SNUPPS

Standardized Nuclear Unit
Power Plant System

April 17, 1984

SLNRC 84-0069 FILE: 0278
SUBJ: Revision in Diesel Generator
Start Time

FIGURE 15.6-7
PEAK CLAD TEMPERATURE
DECLG ($C_D = 0.6$ - MINS
12 SEC 3/6 START)

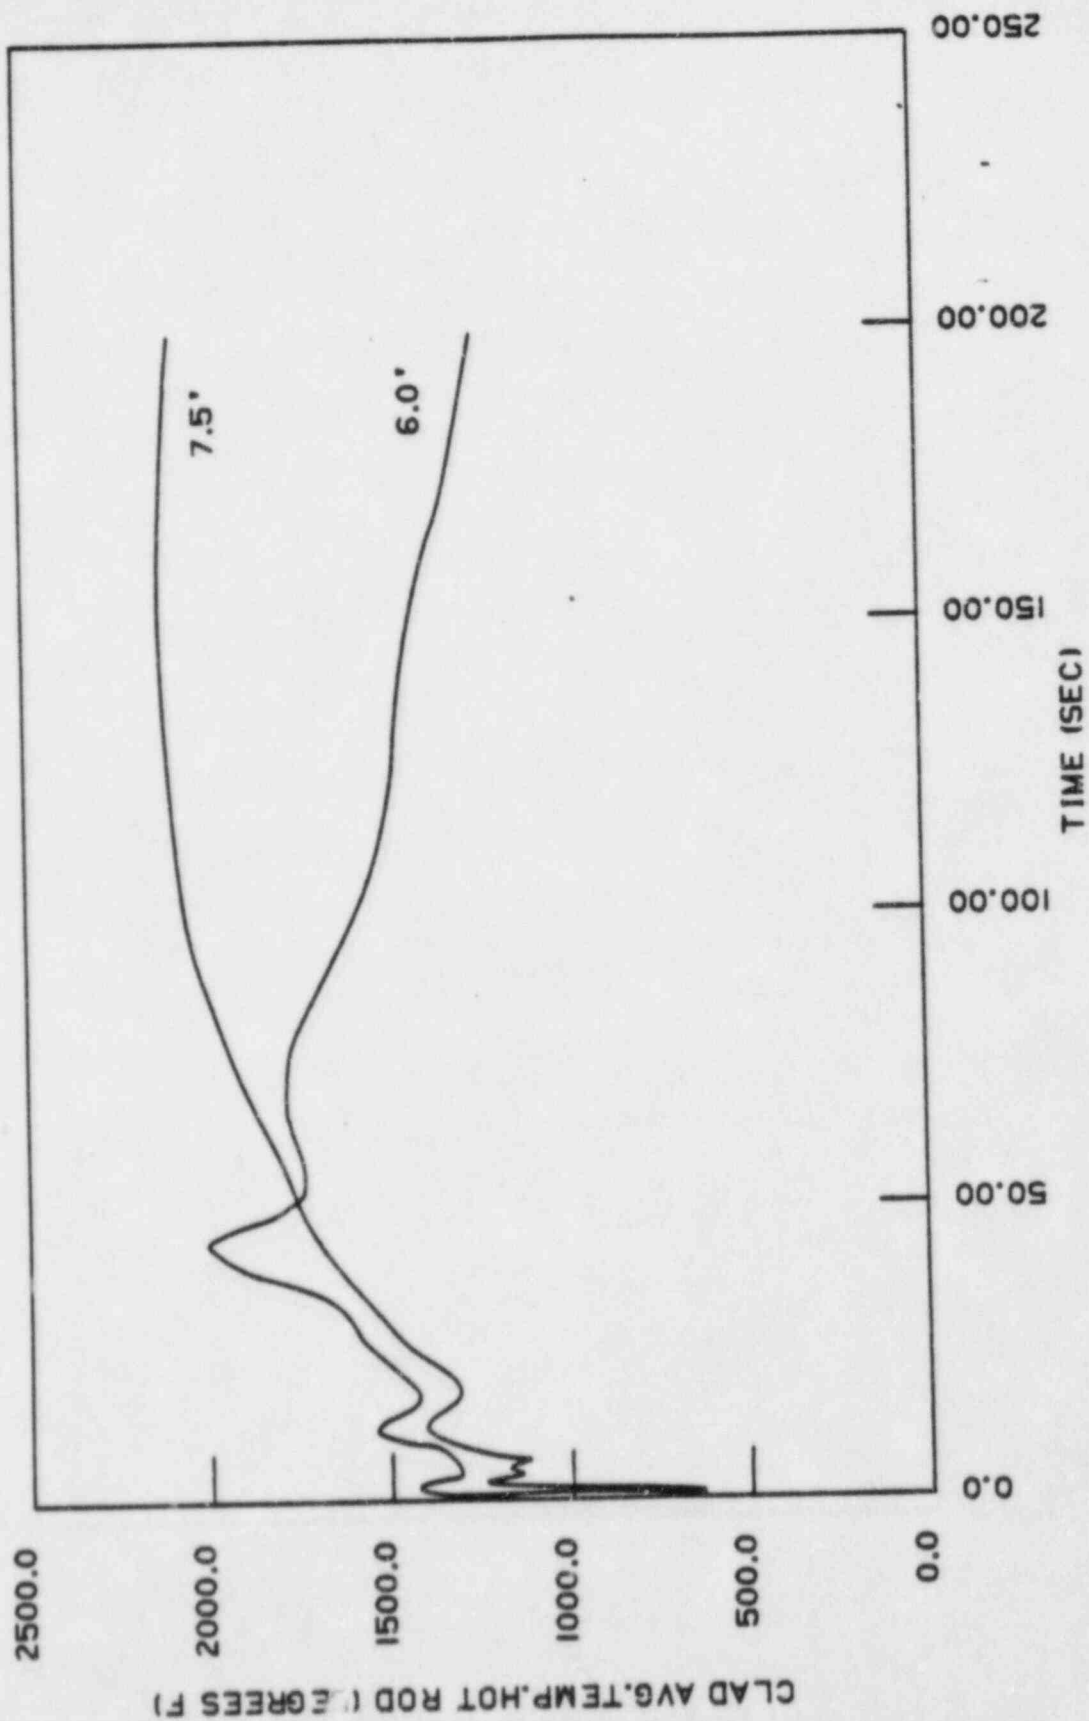
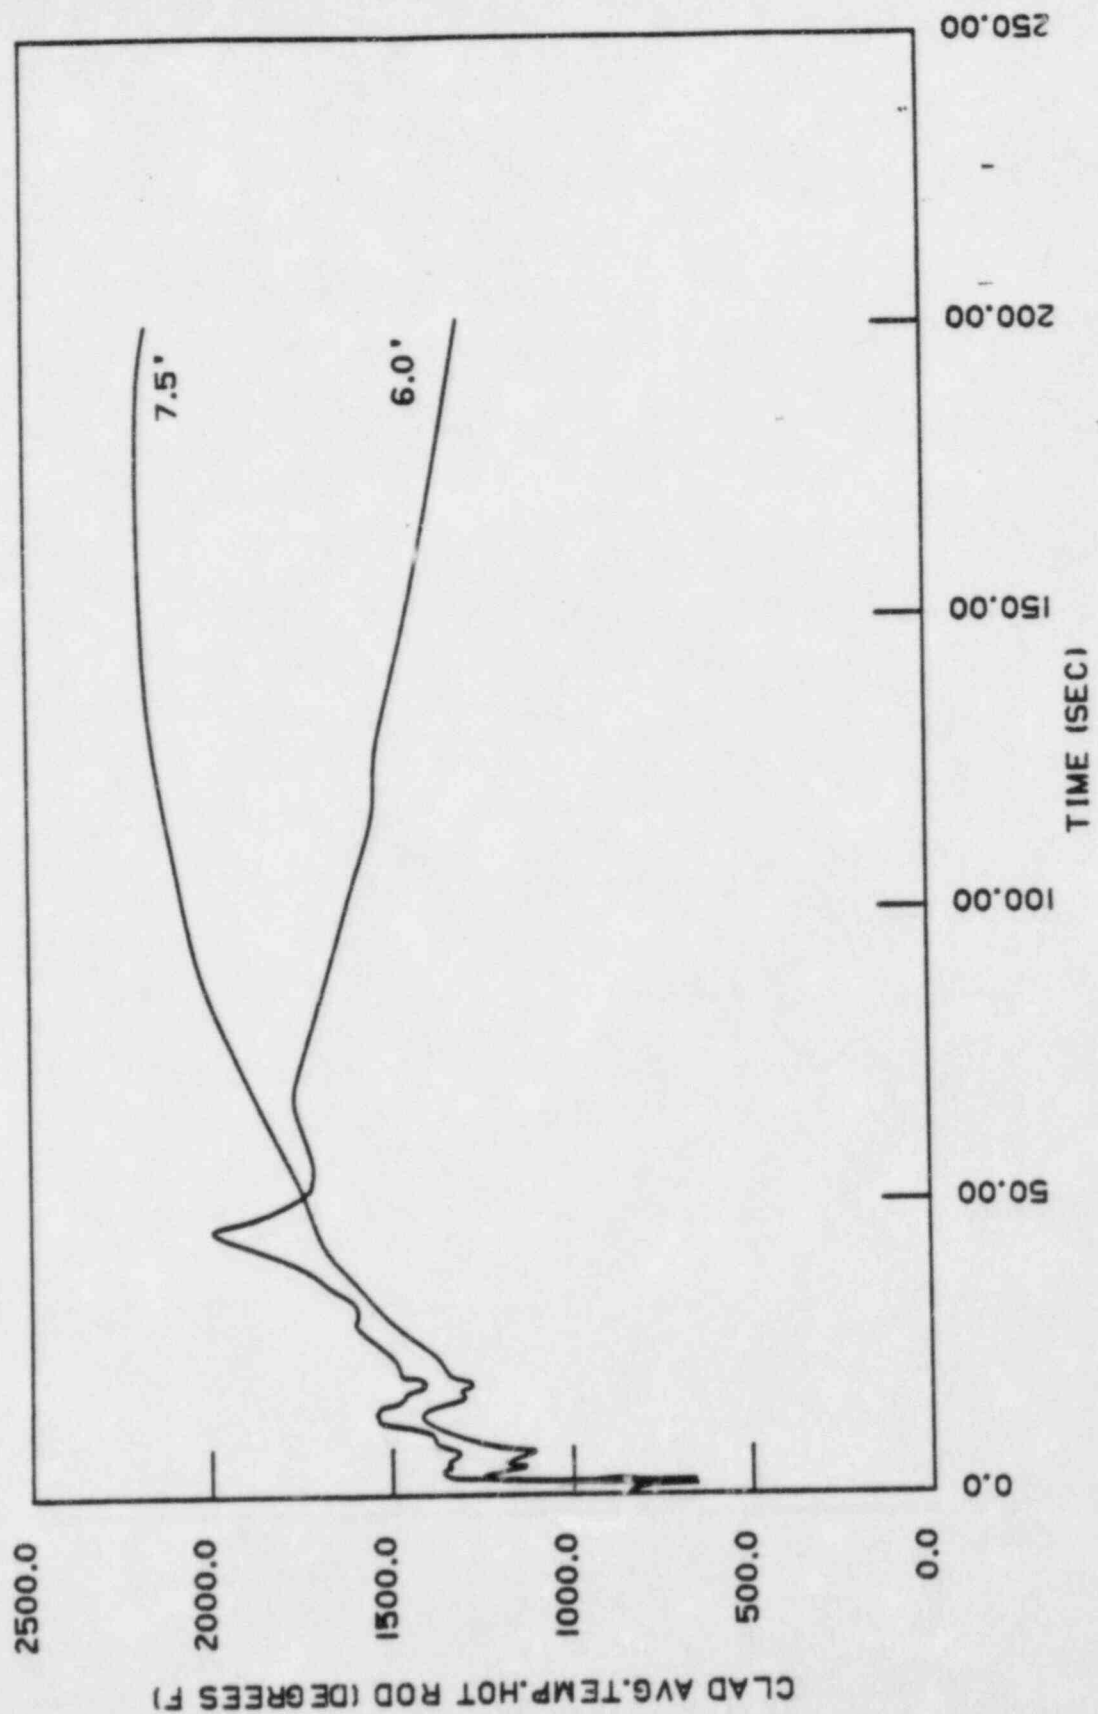
A revision to the emergency diesel generator start time by two seconds (from 10 seconds to 12 seconds) is defined herein. This change in start time is based on providing a more practical method in implementing Technical Specification surveillance requirements in the operation of the Callaway Plant, Unit No. 1 and the Wolf Creek Generating Station, Unit No. 1.

The worst break in the spectrum of break sizes analyzed was a discharge coefficient (C_d) of 0.6. This worst break was analyzed with a 12 second diesel generator start time, to study the effect of a 2 second delay in the start of the diesel generator. Two cases are presented in Table 15.6-11 for the $C_d = 0.6$ DECLG break: The minimum safety injection case and the maximum safety injection case (Reference 27 methodology). The maximum safety injection case proved to be the most limiting.

FIGURE 15.6-9
DECLG ($C_D=0.6$) DOWNCOMER
AND CORE WATER
LEVELS DURING REFLOOD

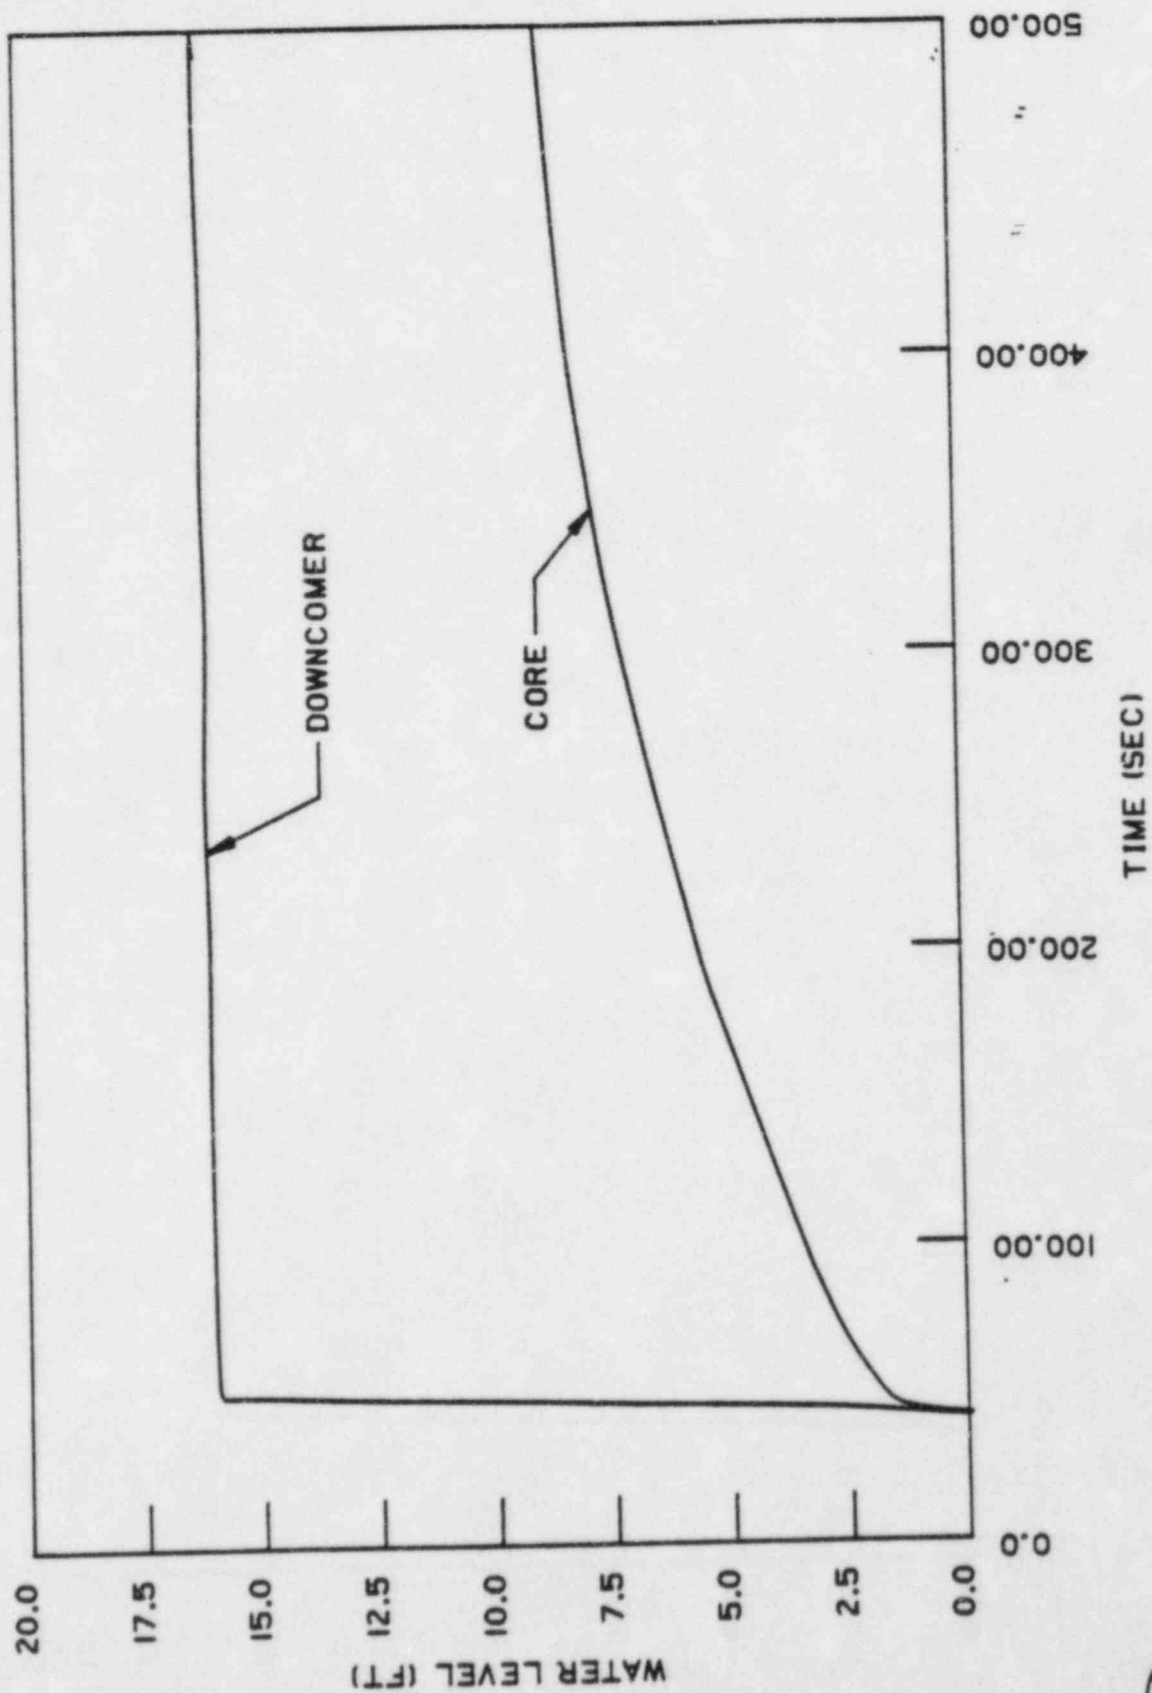
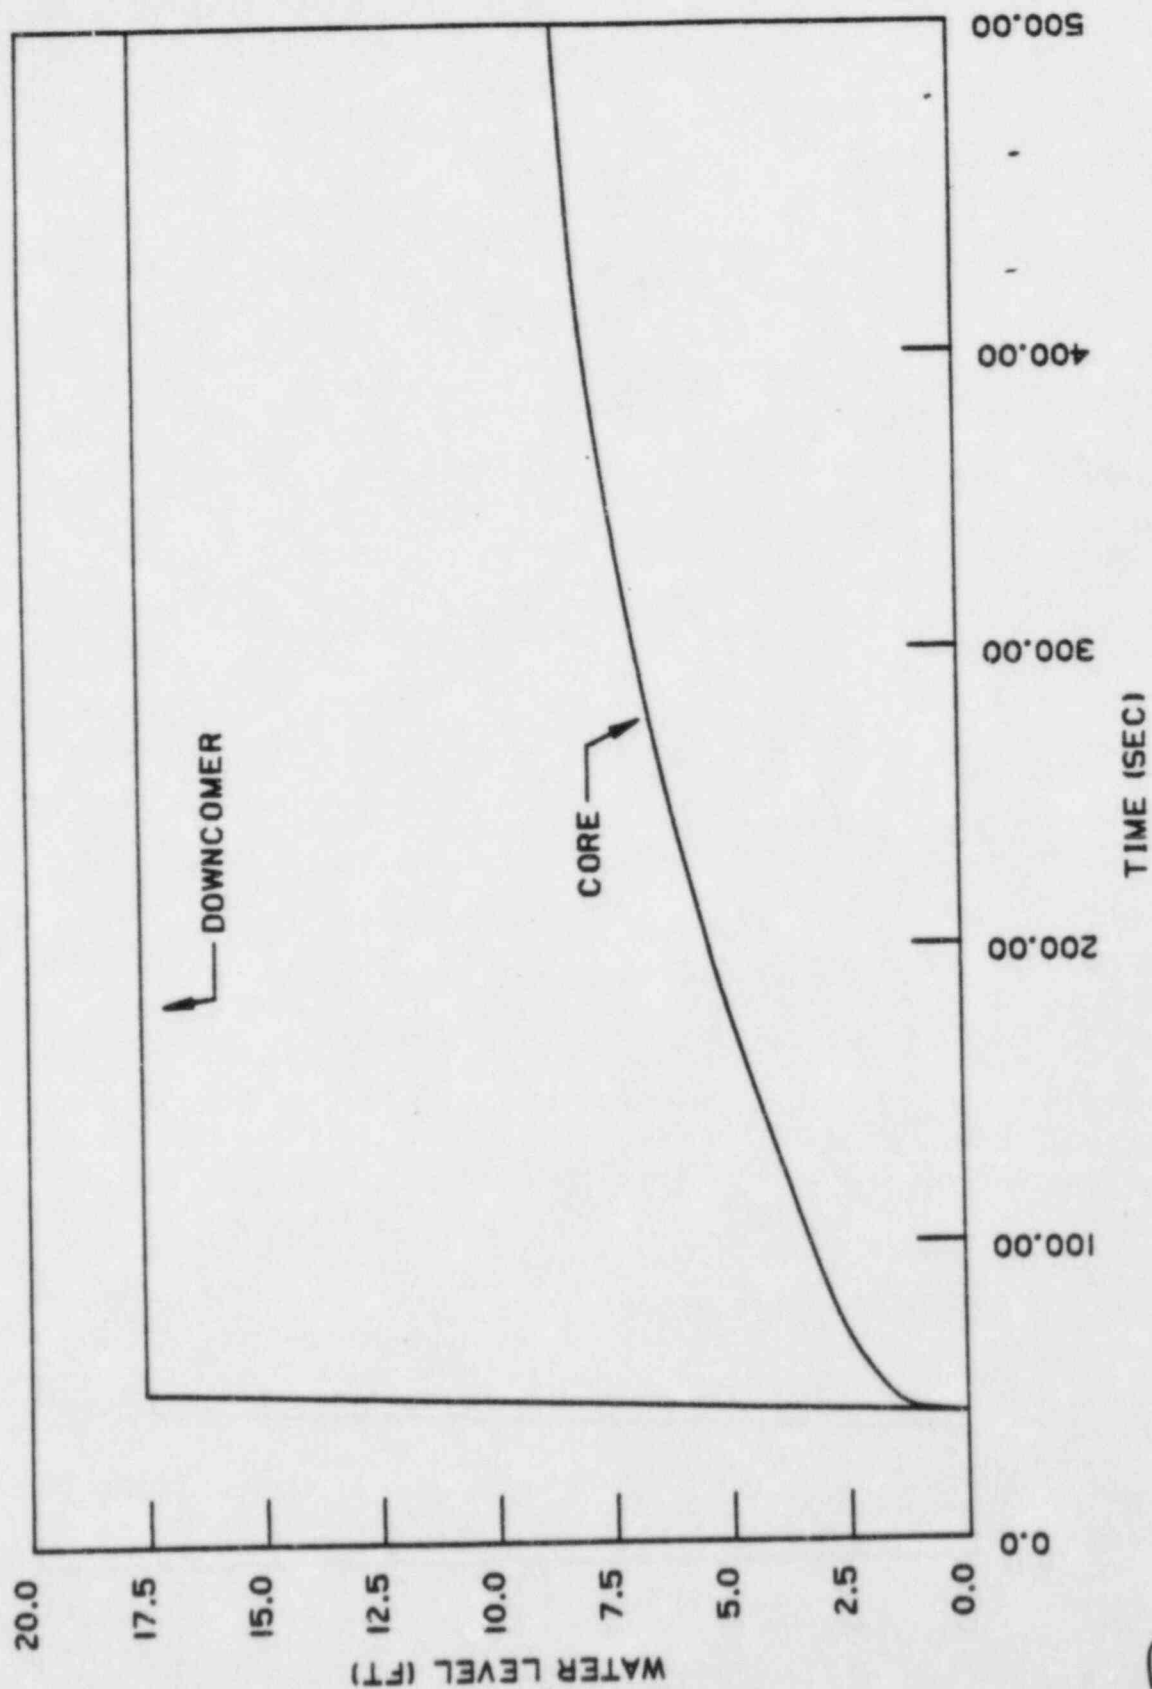
125 SEC
DIG START
